## 產品變更通知 Product Change Notice

No. 20210301  
Date: 2021/03/01

Inalways P/N(華瑋/力瑋)料號 : 0721-6

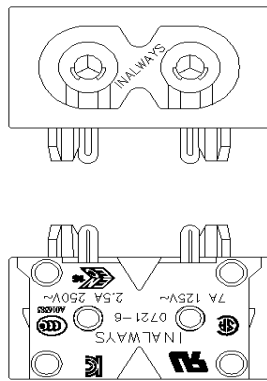
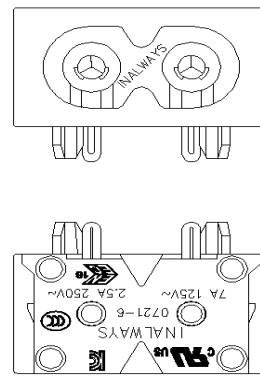
UL is proceeding with UL60320-1 industry file review in 2021, hereby, Inalways is proceeding with safety marking changing as well :

1. CUL marking for full range product (some parts are already with CUL marking)
2. CSA will be expired 2021/8/31
3. CCCs new marking changes to be CCC

1. 因UL+CSA安規符號整合, UL安規刻字符號變更(UL相同檔案號碼: E94191)  
In order to intergrate safety marking from UL to CUL, we conduct the marking changes.
2. CCCs --> CCC 因中國政府發佈命令, 模具採自然切換, 於本次其它安規刻字變更一起進行  
According to China government order of CCCs --> CCC marking, we conduct CCC changing as well
3. 變更後的圖紙如附件  
The drawings are as attached files.
4. 變更刻字後的出貨將於 2021/6/1 開始不晚於 2021/6/30  
The marking changes shipment will be started from 2021/6/1 and no later than 2021/6/30
5. 本變更只有刻字, 未有材質, 設計, 機台及產地變更.  
This PCN is only for marking, there's no changes for material, design, machine and factory.
